**DECLARATION OF TERRY
TOWNSEND IN SUPPORT OF
DEFENDANT RUBY HILL
OWNERS' ASSOCIATION'S
OPPOSITION TO PLAINTIFFS'
MOTION FOR PRELIMINARY
INJUNCTION**

**Reddy Residence
3737 W. Ruby Hill Drive**

**Side-by-side Comparison of
Approved Plans and As-built
Condition**

COLUMNS AT AUTO COURT

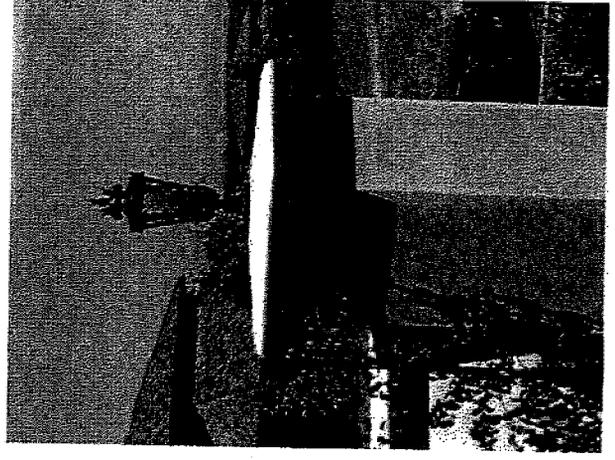
23 34. Columns At Auto Court (Item #2). Exhibit F, page 2, is entitled "Columns at Auto
24 Court." On the left side is the approved Final Design showing a height of 56" for these columns in
25 the front setback. On the right, one photos depicts my measurement with my measuring tape,
26 showing that the height of the column from grade is 68" (in violation of the 60" maximum parameter

Columns depicted on final approved drawings (6.30.10). Height shown at 56".

As-built condition. ADC approved variance of max height of 60". Column measures 68" from grade, w/14" light fixture on top.

SWINGING DOORS FACING STREET AT LANAI (GARAGE)

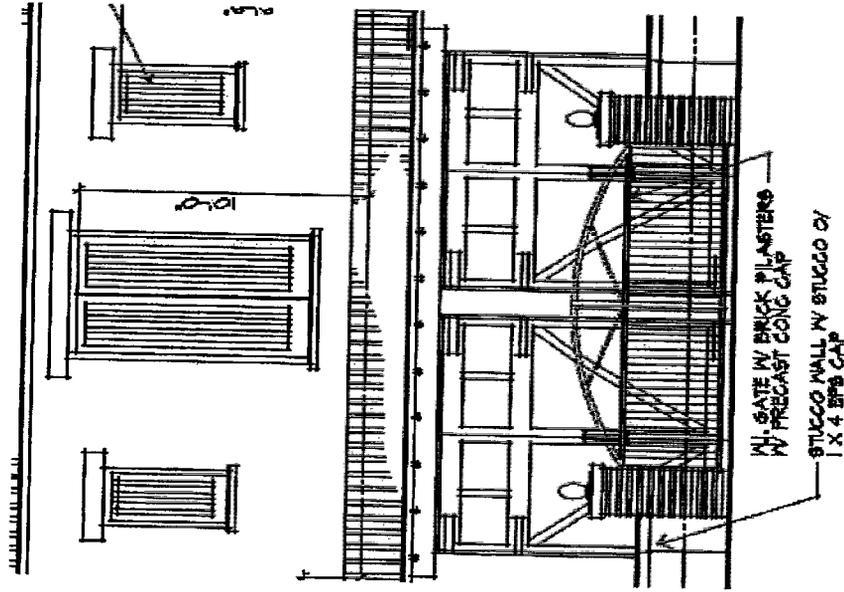
4 35. **Swinging Doors Facing Street (Garage) (Item #4)**. Exhibit F, page 3, is entitled
5 "Swinging Doors Facing Street At Lanai (Garage) and page 4 is entitled "Swinging Doors Facing
6 Street At Garage. The Reddys in their Final Design approved on June 30, 2010 had proposed a
7 garage and not a lanai. The drawing on the left side depicts a garage. The doors are simple, and
8 solid wood to match adjacent garage doors. This style as shown in their Final Design is in keeping
9 with the Monterey/Spanish Eclectic Style as I discussed on the third page of my August 2, 2012
10 letter to Bob Jones. (Ex. C.) The as-built condition does not. The as-built condition violates the
11 Design Guidelines and is not in keeping with the Monterey/Spanish Eclectic Style. The photo on
12 the right shows the exterior of the residence where the original garage space was converted to a
13 lanai without the approval of the ADC. The space must remain as a garage. The glass utilized by

Garage depicted on final approved drawings (6.30.10) – Doors are simple, solid wood to match adjacent garage doors.

As-built condition. Original garage space converted to a “lanai”. Lanai concept not approved – space must remain a garage. Glass is not allowed in garage doors. Iron work and gold accenting is too ornate and would not be approved if submitted.

SWINGING DOORS FACING STREET AT GARAGE

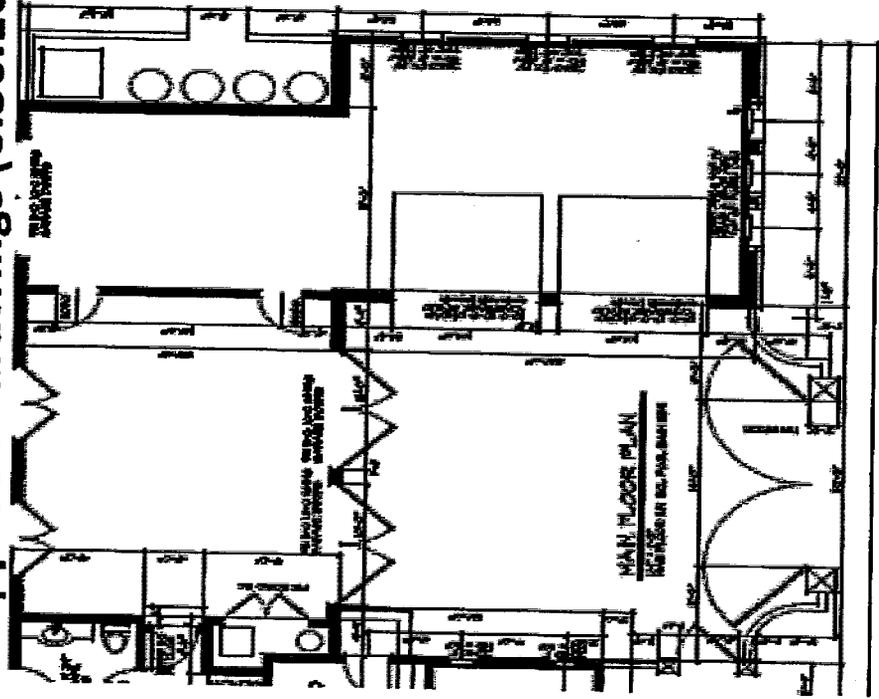
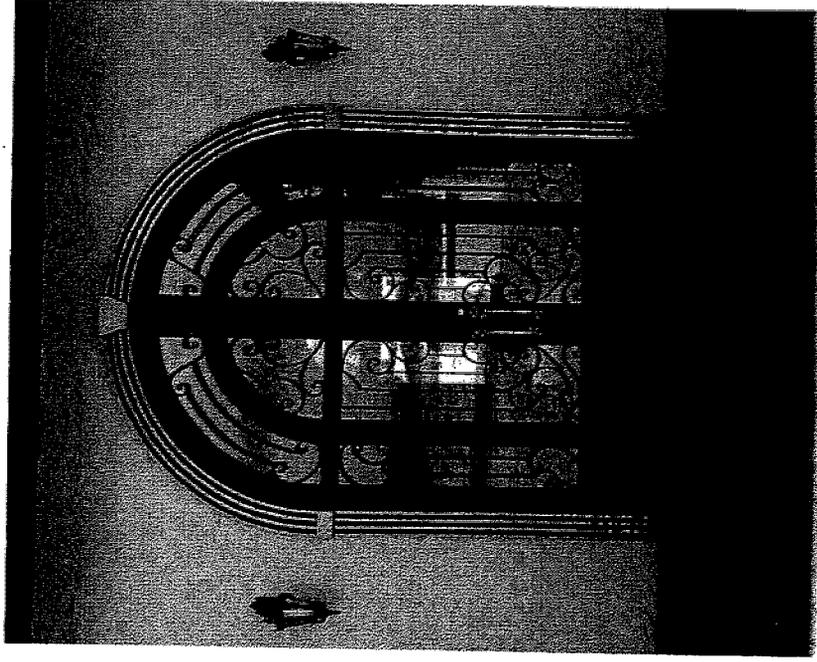
Floor plan of garage depicted on final approved drawings (6.30.10).

As-built condition. Original garage space converted to a "lanai". Lanai concept not approved – space must remain a garage. Glass is not allowed in garage doors. Iron work and gold accenting is too ornate and would not be approved if submitted.

EXTERIOR COLORS -- FRONT ELEVATION

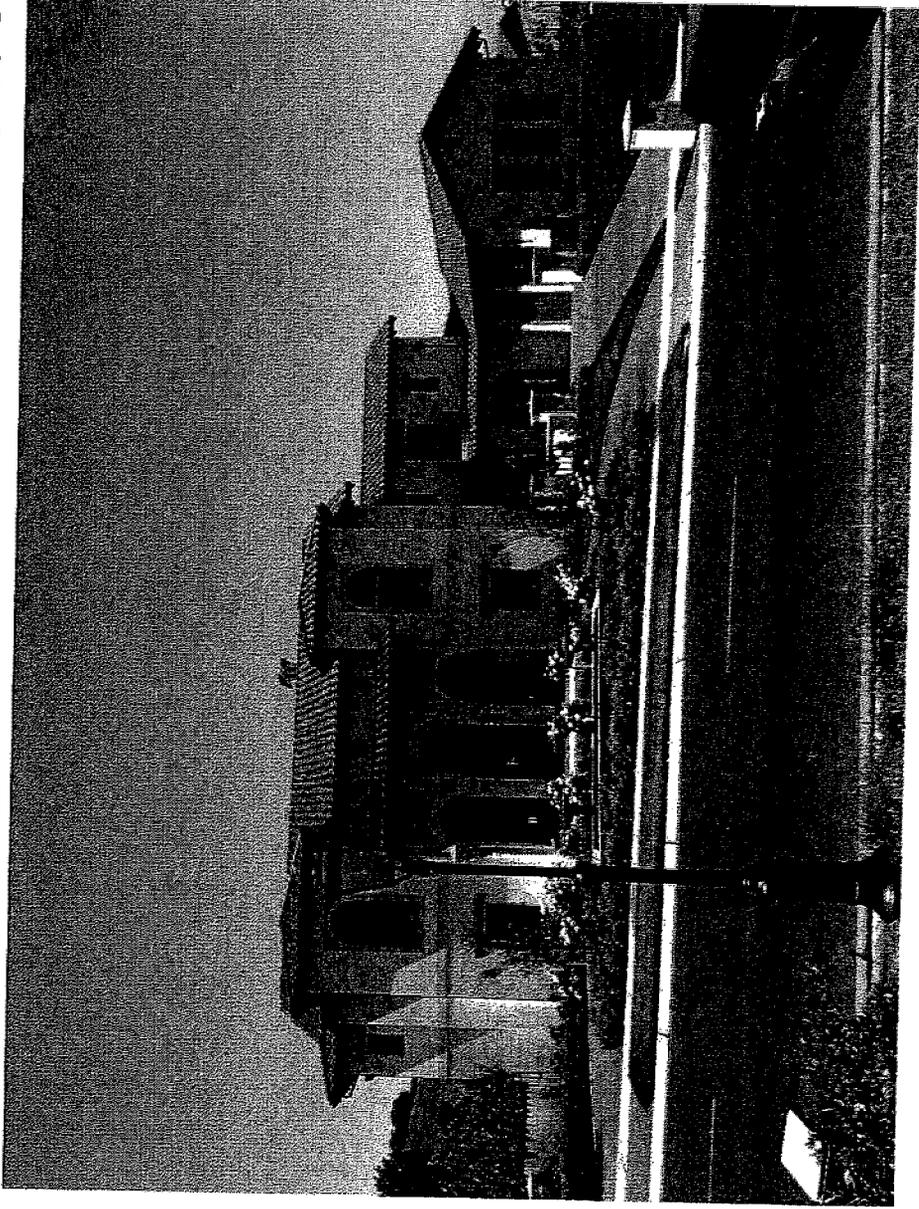
20 36. **Exterior Colors - Front Elevation (Item #12)**. Exhibit F, page 5, is entitled
21 "Exterior Colors - Front Elevation". The allegations of the Reddys in Paragraph 26 (12) of the
22 Reddy Complaint at pp. 8:12-9:6 are not true. No specific colors were submitted by the Reddys on
23 the approved Final Designs. The Reddys never submitted colors and materials for approval to the
24 ADC. The Reddys never provided the ADC with a La Habra color card with color chips. No
25 boards or samples were provided to the ADC for consideration. As reflected in the Design
26

Colors and materials never submitted for approval. Stark white, bright pastels or bright intense colors in large expanses are not allowed. The ADG prohibits harsh contrasts of color and/or materials; illogical or inappropriate combinations of scale

EXTERIOR COLORS – REAR ELEVATION

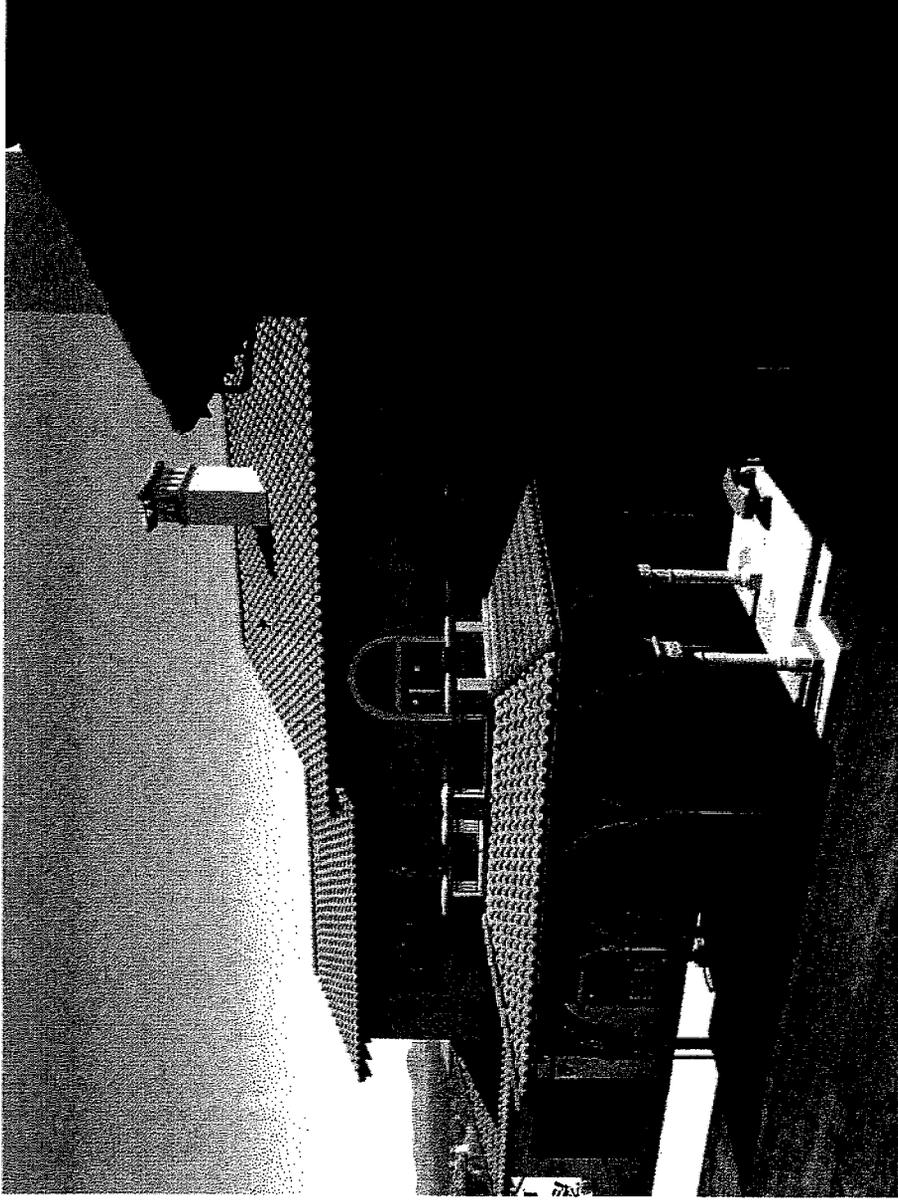
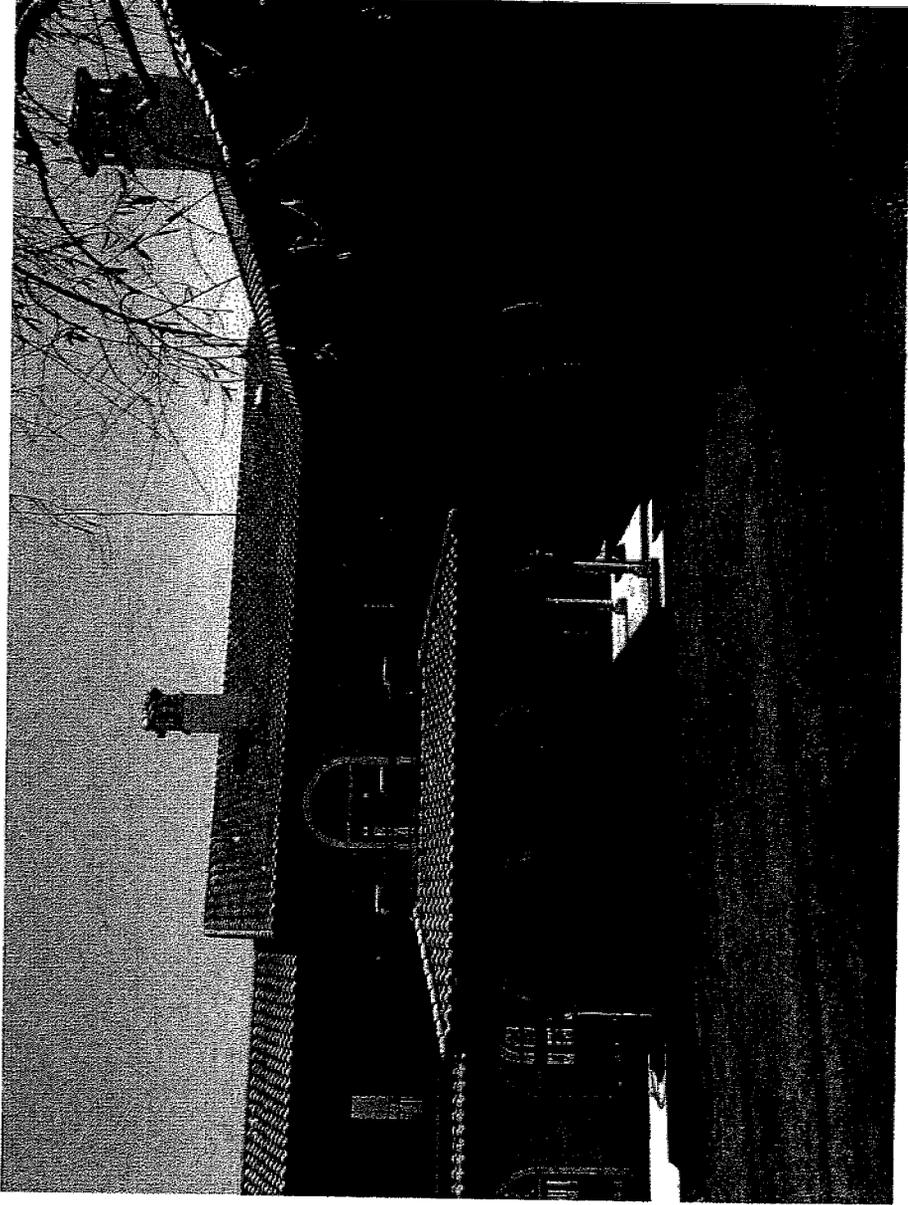
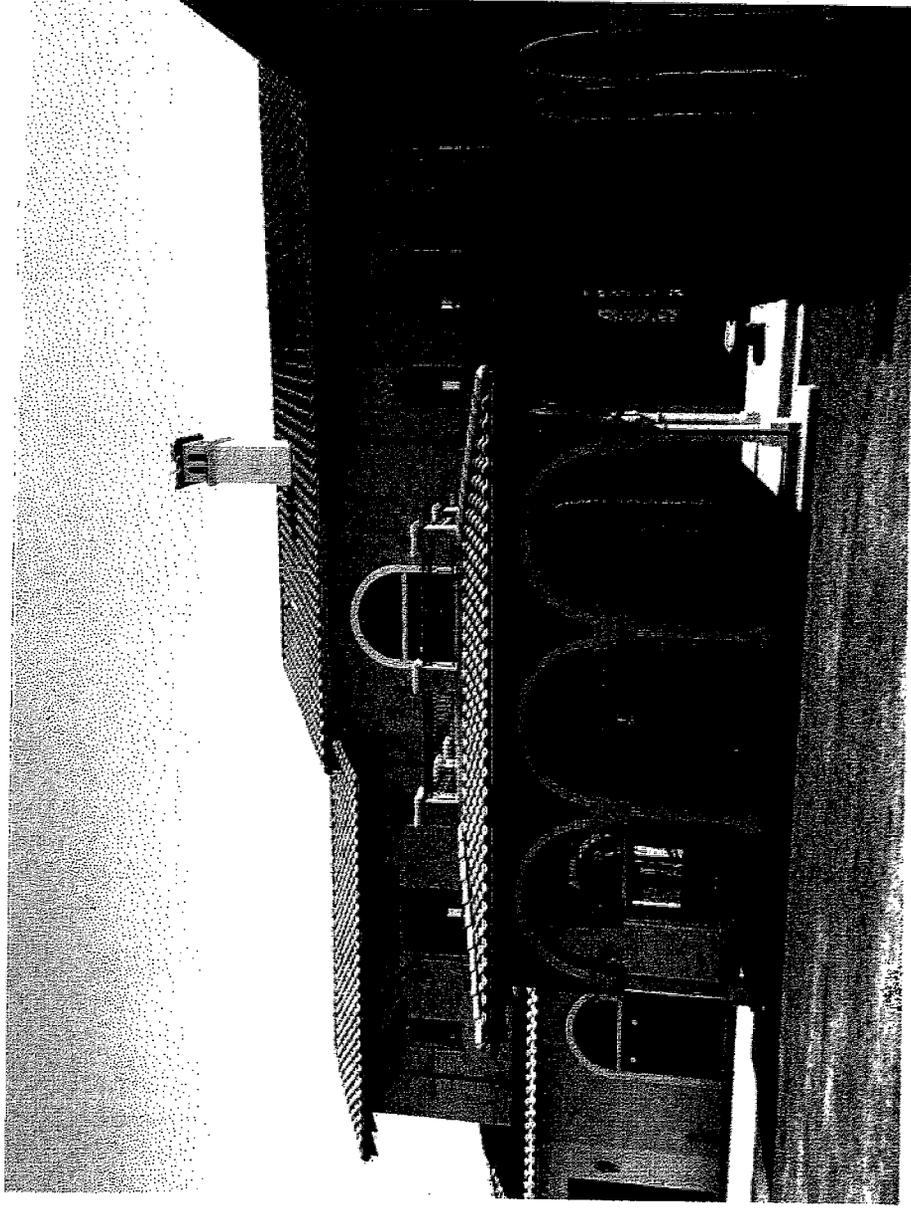
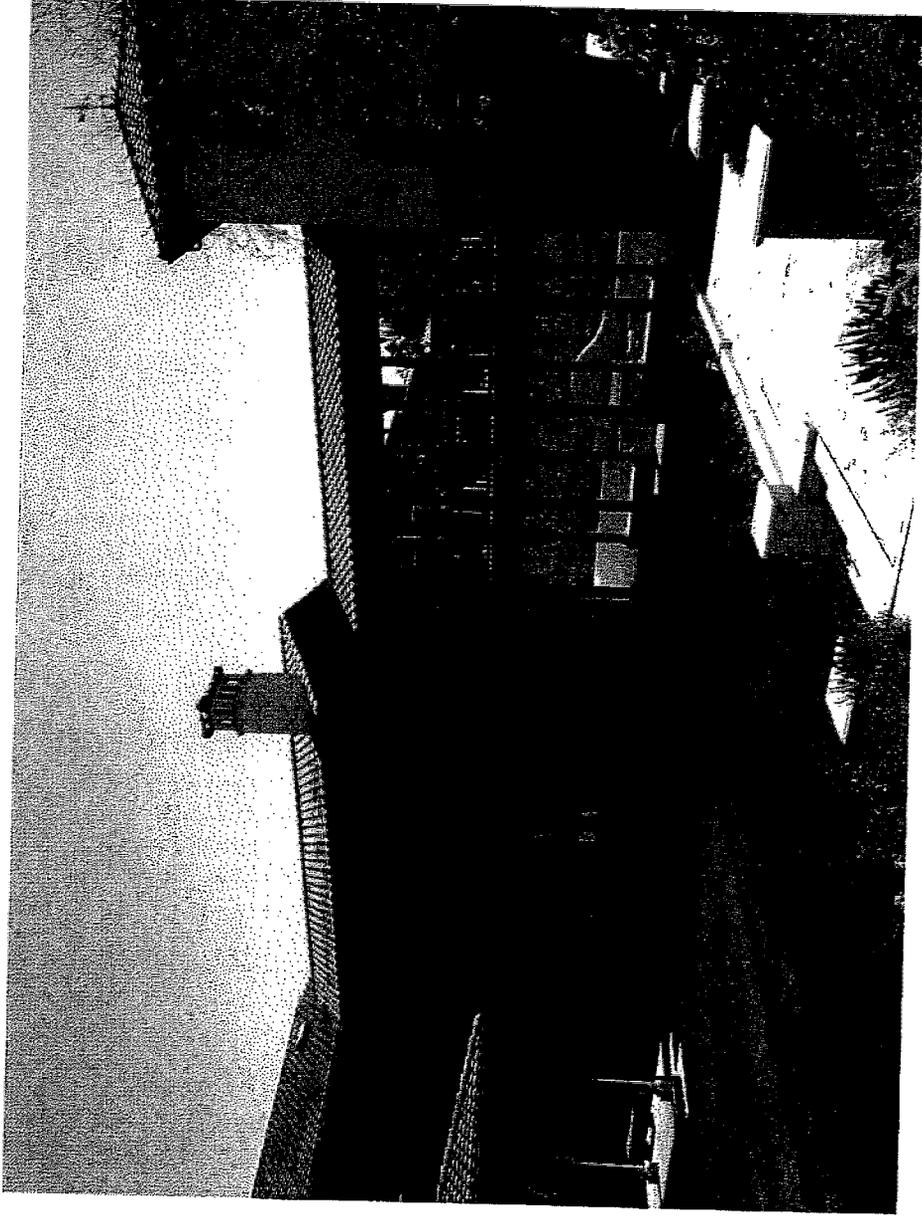
Colors and materials never submitted for approval. Stark white, bright pastels or bright intense colors in large expanses are not allowed. The ADG prohibits harsh contrasts of color and/or materials; illogical or inappropriate combinations of scale. There are 9 different colors applied to the body on the rear.

Colors and materials never submitted for approval. Stark white, bright pastels or bright intense colors in large expanses are not allowed. The ADG prohibits harsh contrasts of color and/or materials; illogical or inappropriate combinations of scale

Colors and materials never submitted for approval. Stark white, bright pastels or bright intense colors in large expanses are not allowed. The ADG prohibits harsh contrasts of color and/or materials; illogical or inappropriate combinations of scale

Colors and materials never submitted for approval. Stark white, bright pastels or bright intense colors in large expanses are not allowed. The ADG prohibits harsh contrasts of color and/or materials; illogical or inappropriate combinations of scale
